TO: Design Review Commission
FROM: Zachary Dahl, Planning Services Manager
SUBJECT: 18-V-06 – 714 Arroyo Road

Consider variance application 18-V-05 to allow an existing accessory structure to be maintained

This is a variance request to allow for increased height, reduced setbacks and a daylight plane encroachment for an existing accessory structure (described as a treehouse by the applicant) located in the rear yard of the property at 714 Arroyo Road. The project includes variances to the City's Accessory Structure Ordinance (Zoning Code Chapter 14.15) to allow a height of 24 feet where the maximum height is 12 feet, side and rear yard setbacks of approximately four feet where a minimum of five feet is required and encroachments into the side and rear yard daylight plane.

MEASUREMENTS

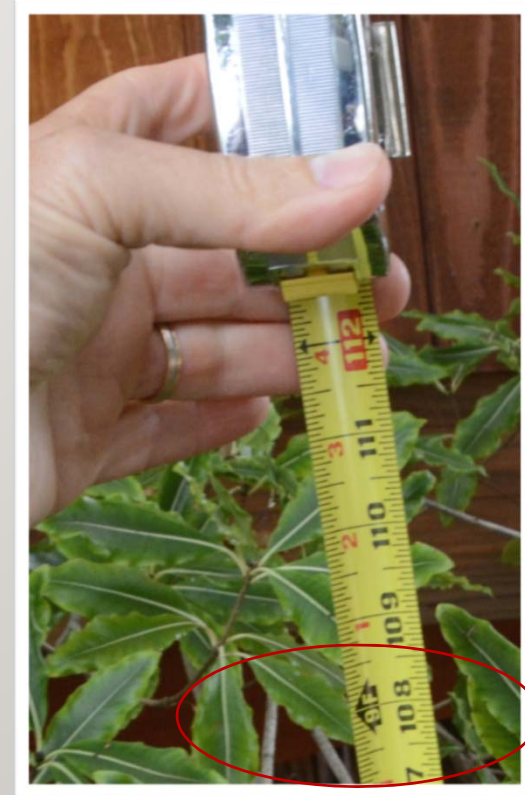
- We were not consulted
- Multi-story structure
 - We estimate ~30 ' high
- Only 4' from our fence
- 26' from our bedroom window
- Higher than the 240V wires

4' 2" from fence

Base almost 9' off ground

19' or more (9'+>10') to top of siding

I ESTIMATE BETWEEN 28 AND 35' TO TOP LEVEL

- Safety
 - The huge redwood trees blow and bend in winter storms
 - Does this work weaken the tree or root system? Has an arborist been consulted?
 - If tree dies (as ours did in that corner) then even bigger impact
 - The top of the structure is higher than the 240V wires
 - If this is a temporary playhouse, will it be safe during an earthquake?
- Other
 - Light plane is obstructed
 - Proximity to fence and our house impacts privacy
 - Immense size, proximity and visibility effect resale value of our home
 - Lack of compliance with stated code enforced for such structures

1. Comply with the code
 1. Build 25' away or limit to 12' high
2. Please plant mature trees between fence and future structure
3. Please thin out redwood tree branches, to reduce wind load in winter storms
